**Re:**           **Second Submission Review:**   1900 S Chambers Community Lot 1 - Site Plan Amendment Amdt.  
                  **Application Number:**         DA-2105-01  
                  **Case Numbers:**             2018-6020-03

Please use this cover letter as a guide for the Second Submittal of 1900 S Chambers Community Lot 1 – Site Plan Amendment. The following pages detail the response to your comments, and no major changes have occurred since the previous submittal. If you have any comments or concerns, please give call or email me. I may be reached at 817.687.8846 or [gbogdanoff@pnt-llc.com](mailto:gbogdanoff@pnt-llc.com).

## SITE PLAN

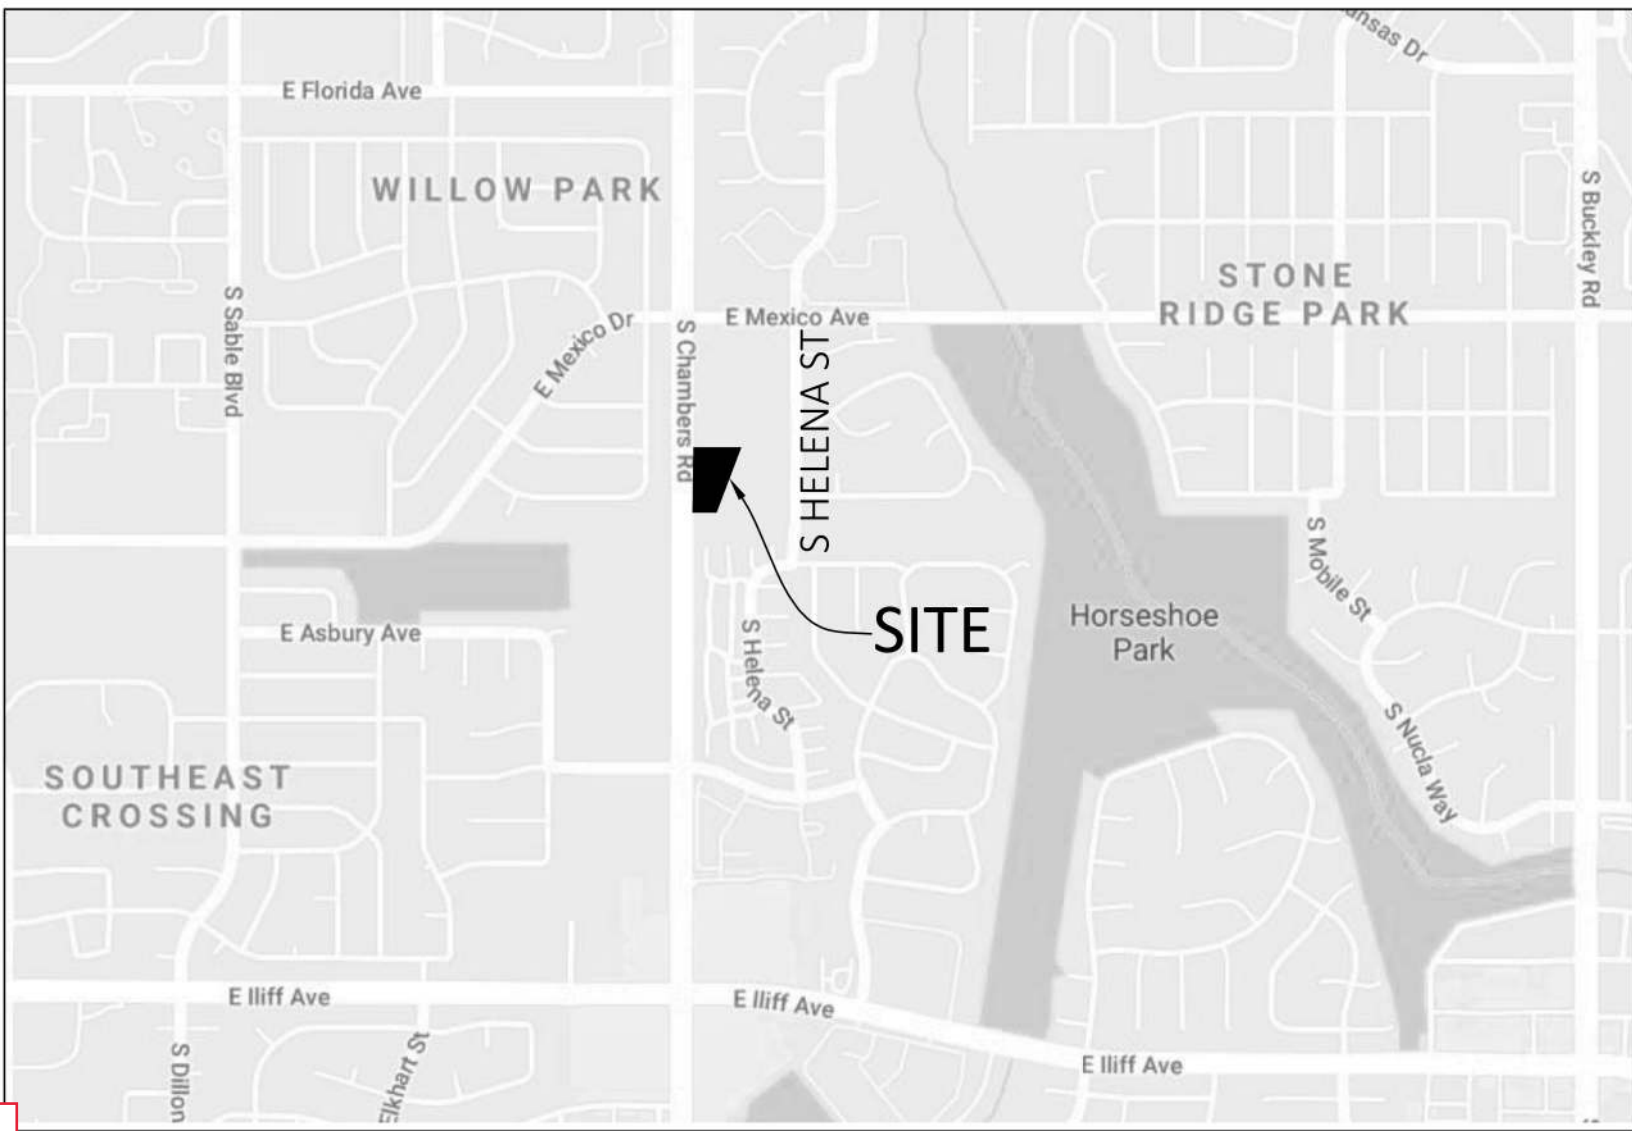
Correct maximum  
building height from 60'  
to 45' per city code for  
Subarea B.

Required number of  
accessible parking spaces  
required is 3. Update to  
plan to meet this  
requirement

Add the number  
required and  
number of bicycle  
parking spaces  
being provided to  
the data table.

ADDED BICYCLE  
REQUIREMENTS  
AND PROVISION.

GRADING PLAN

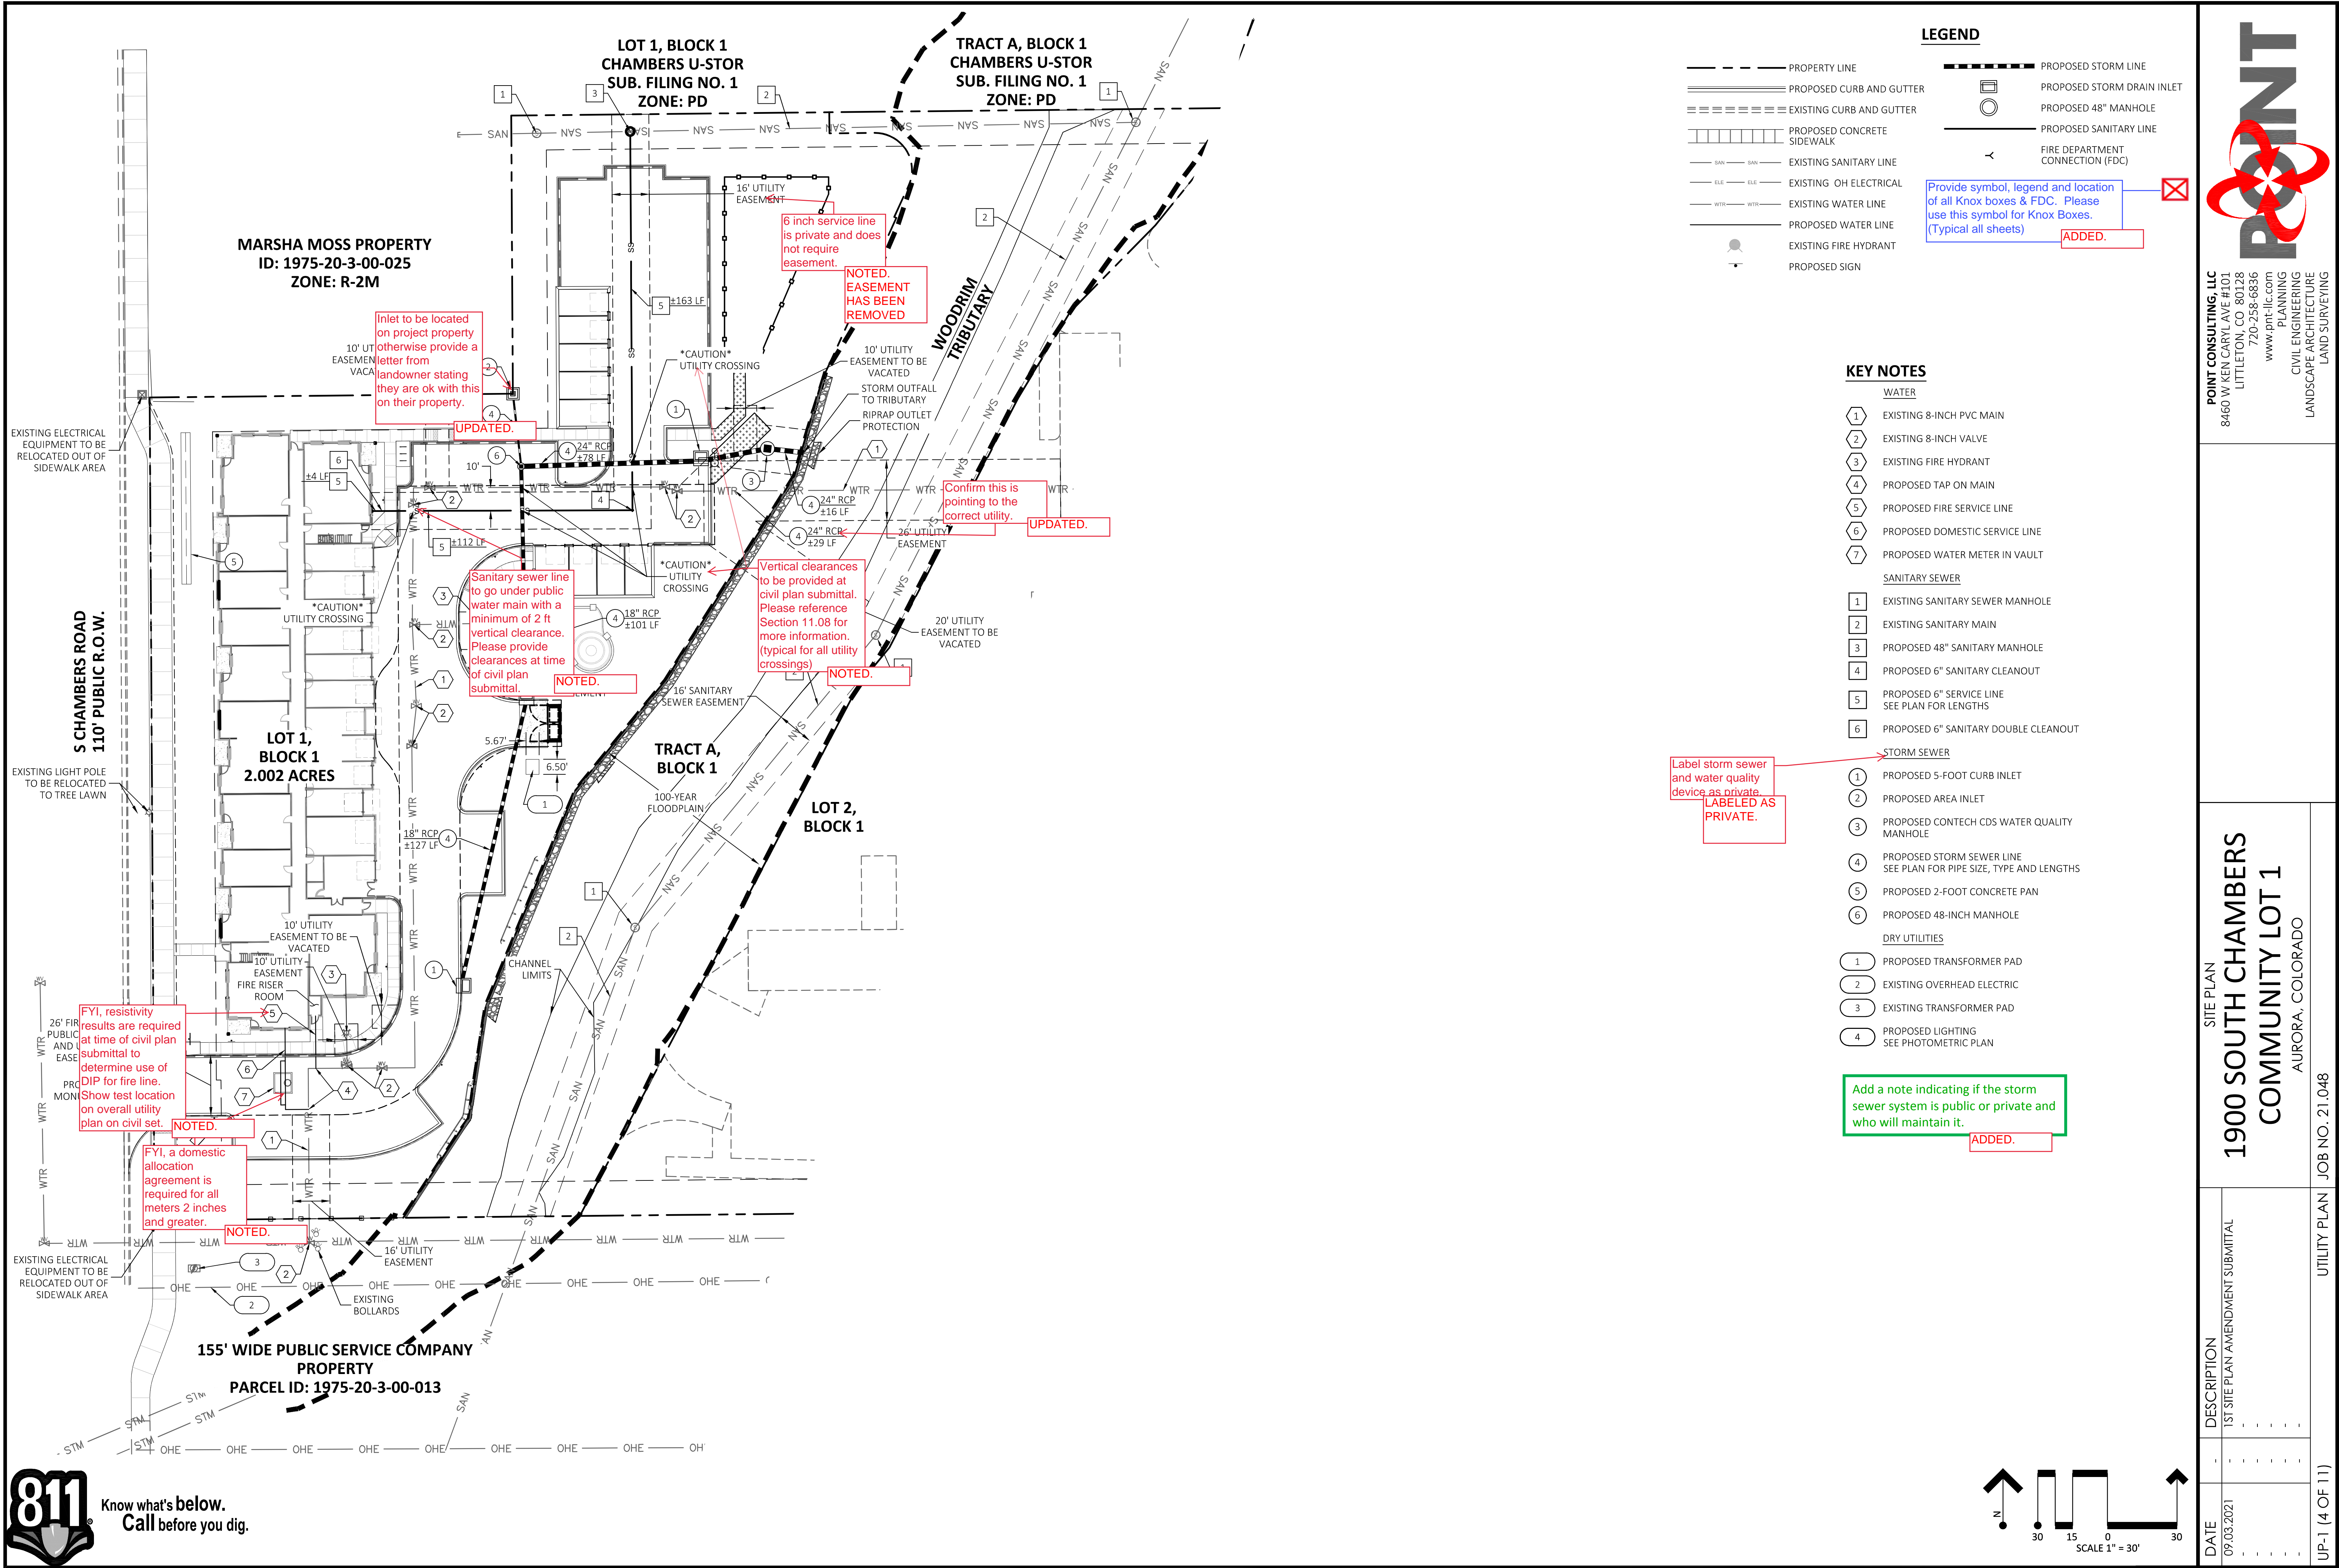
Add a note indicating if the storm sewer system is public or private and who will maintain it.

TRASH ENCLOSURE DETAIL

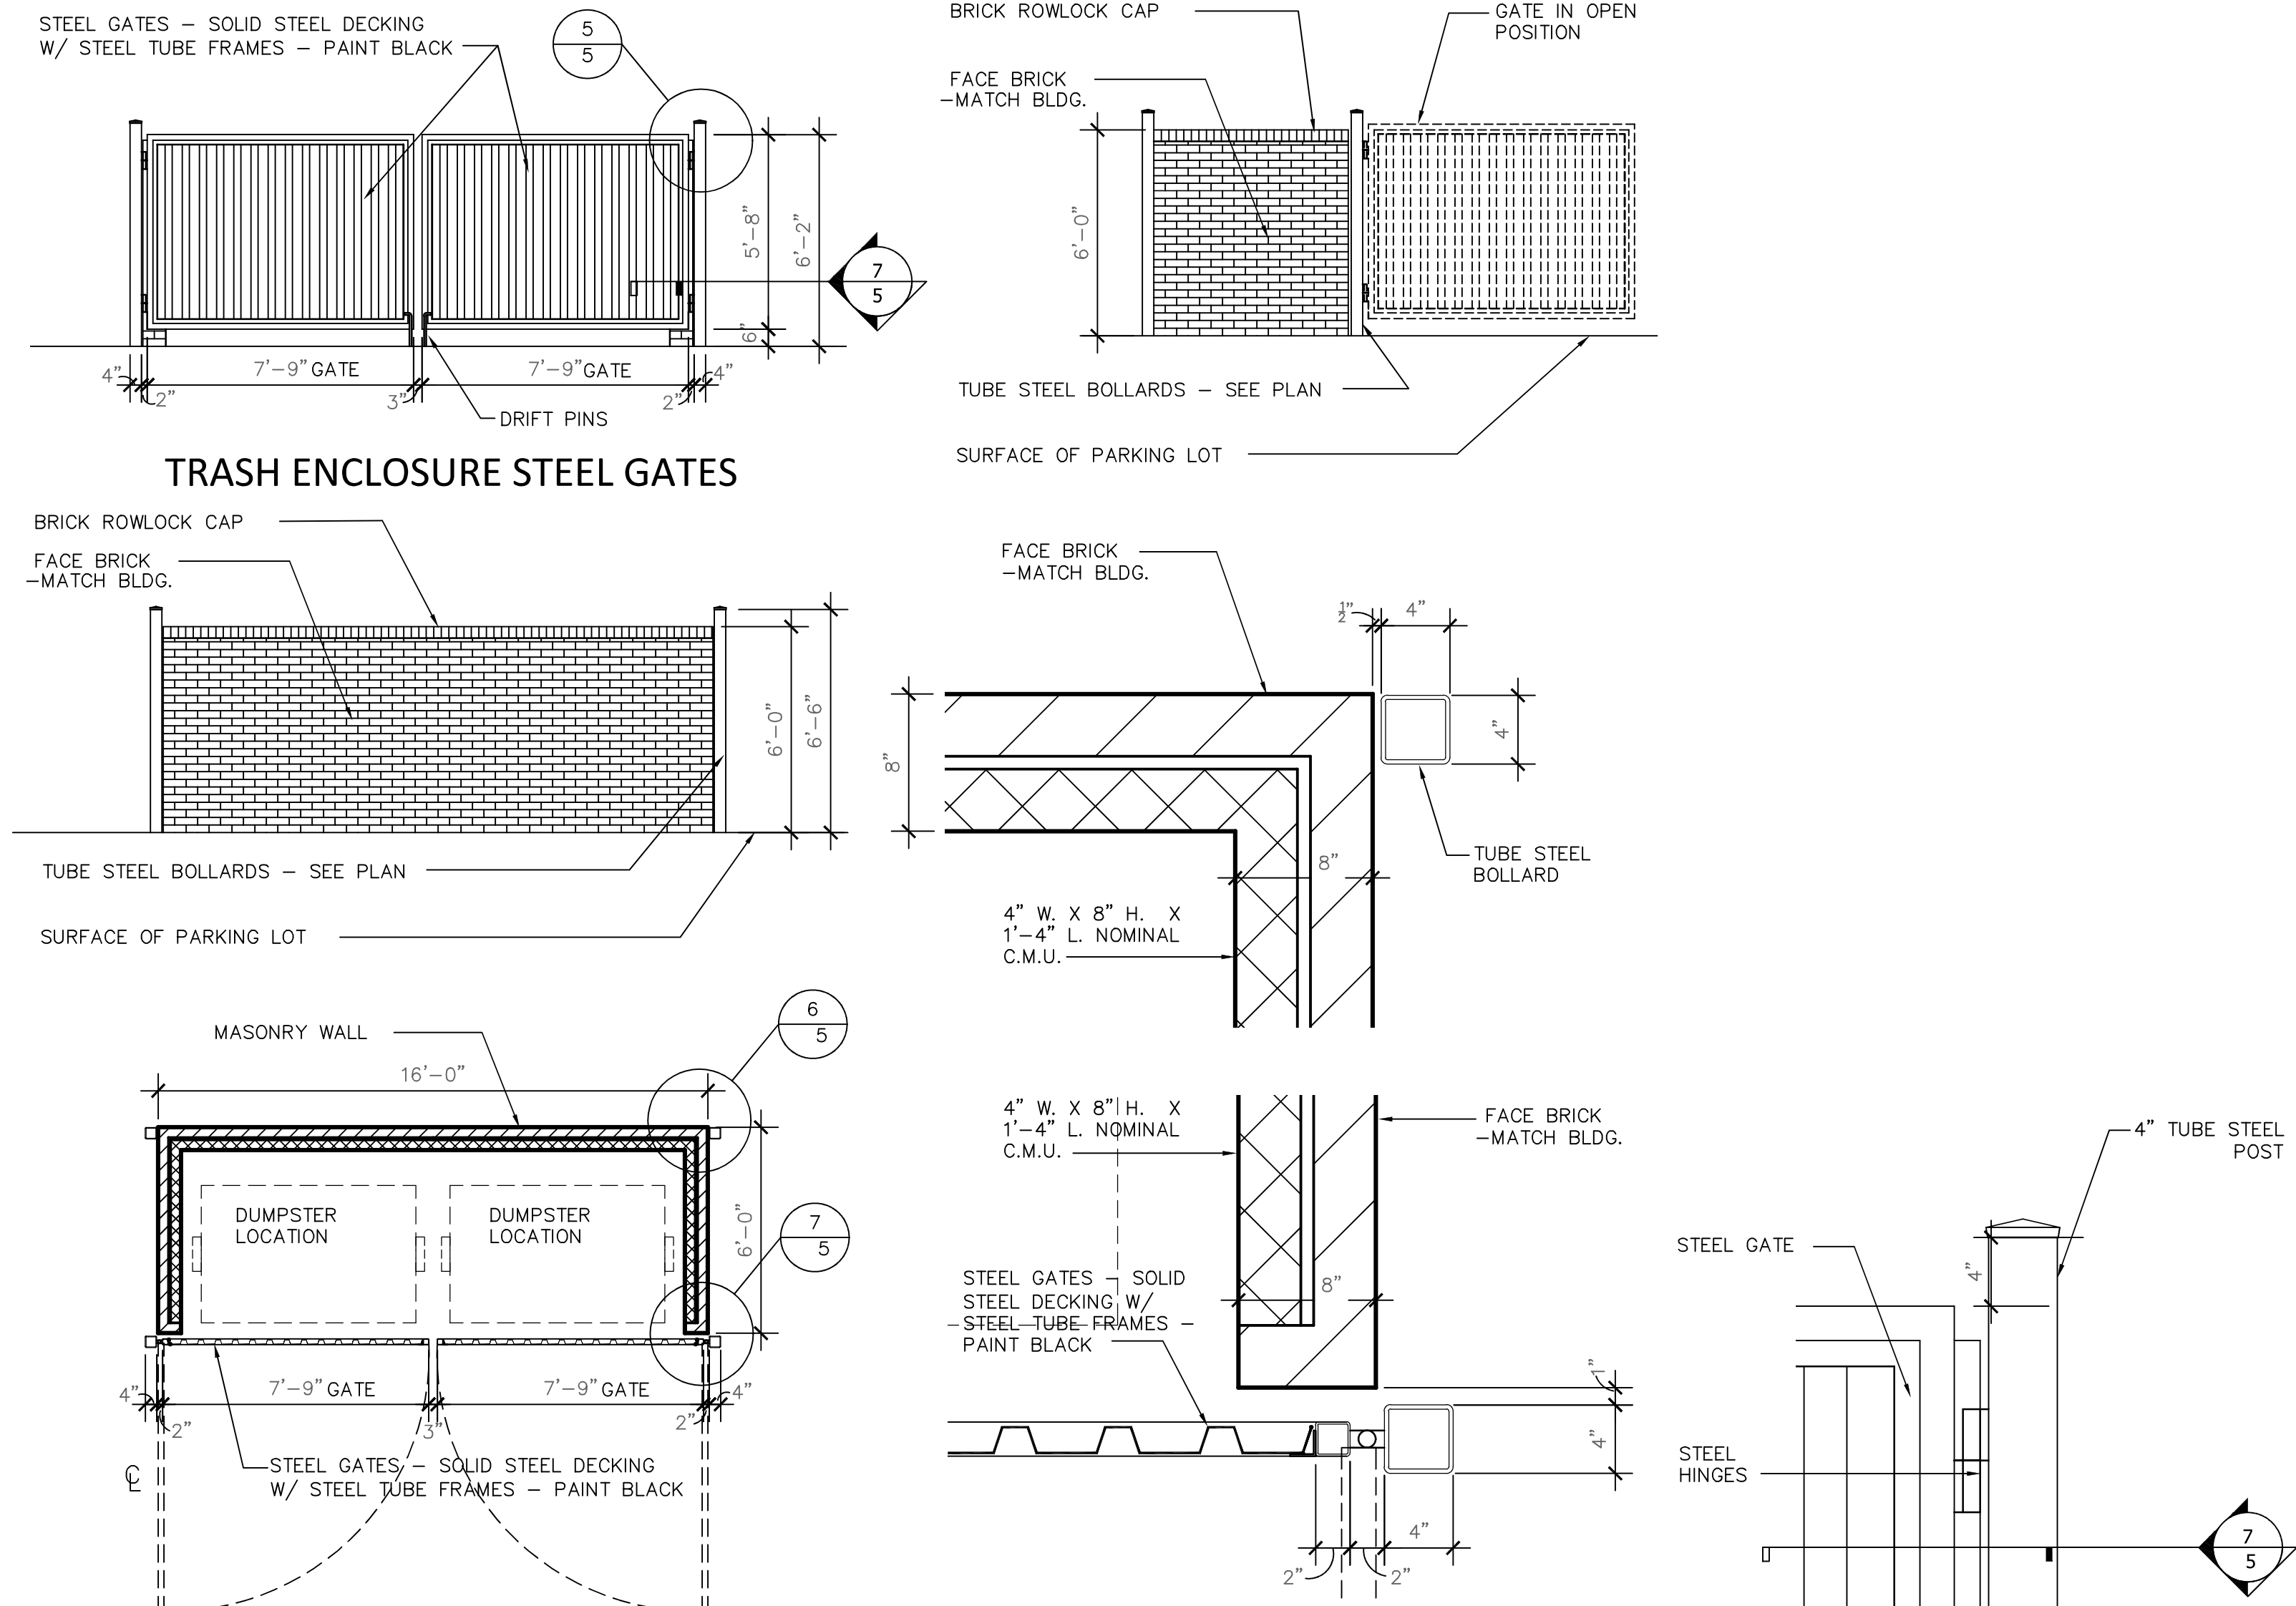
Provide a detail of the retaining wall including height, color and material.

Landscape details sheet has been updated to show this detail

4 WEST ELEVATION  
3/32" = 1'-0"

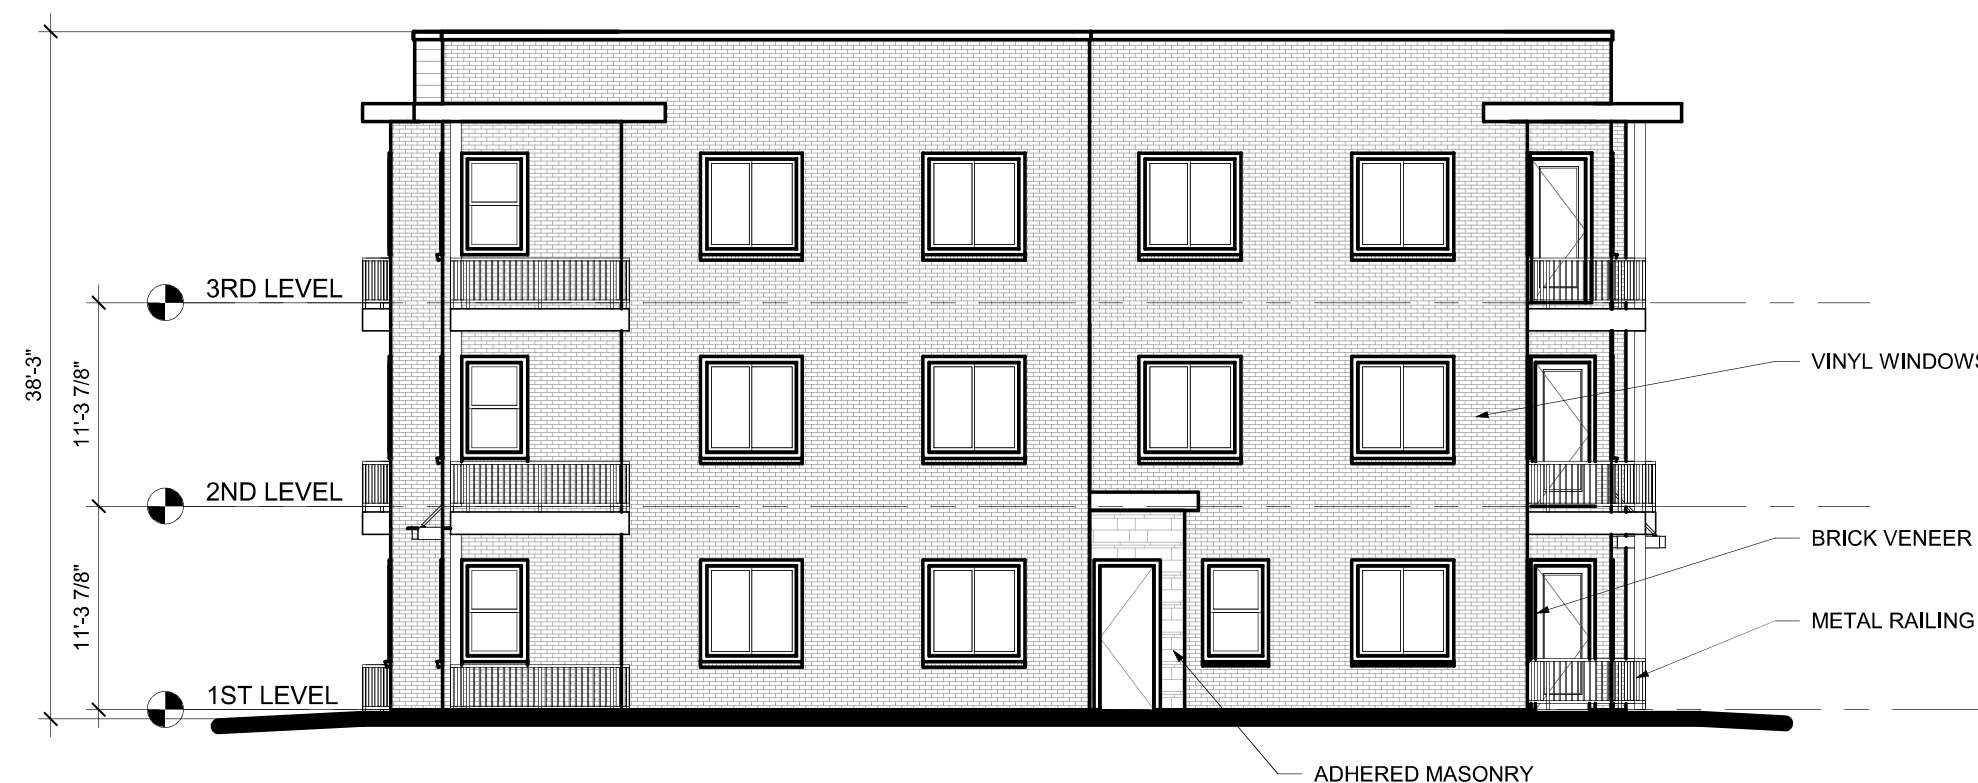
The primary façade which is the west elevation should have  
a main pedestrian entry per city code.

Add an enhanced entry to design to a  
main entrance off of Chambers Road.  
There should be accentuated entrance  
using one of the following methods -  
projected mass, recessed mass, corner  
entry, roof form variation, awning or  
sunshade device. This should be shown  
in updated elevations.

NOTED. EMPHASIZED  
ENTRANCE
